YANKEE NUCLEAR POWER STATION (YANKEE-ROWE)

AMENDMENT TO FACILITY OPERATION LICENSE

Amendment No. 53
License No. DPR-3

ATTACHMENT TO LICENSE AMENDMENT NO. 53

Figure 3.2.1

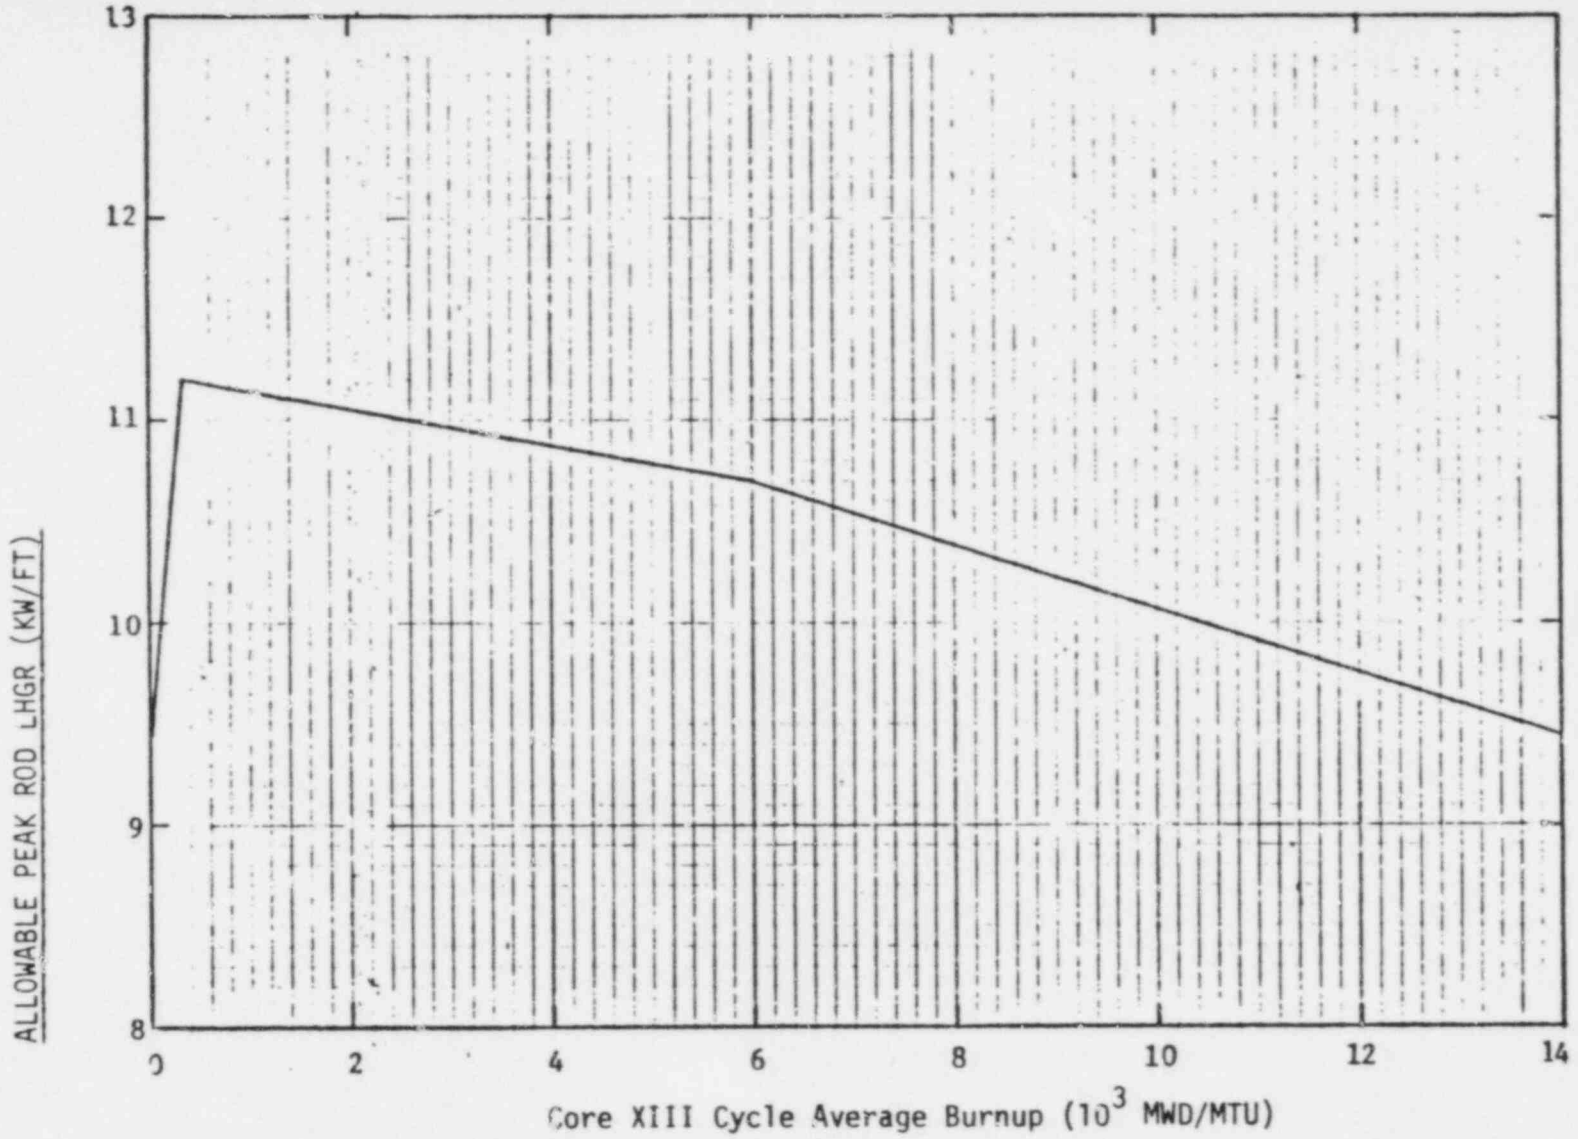
3.2.1 The peak linear heat generation rate (LHGR) shall not exceed the limits of Figure 3.2-1 during steady state operation in Cycle XIII.*

4.2.1.1 The peak LHGR shall be determined to be within the limits of Figure 3.2-1 using incore instrumentation to obtain a power distribution map:
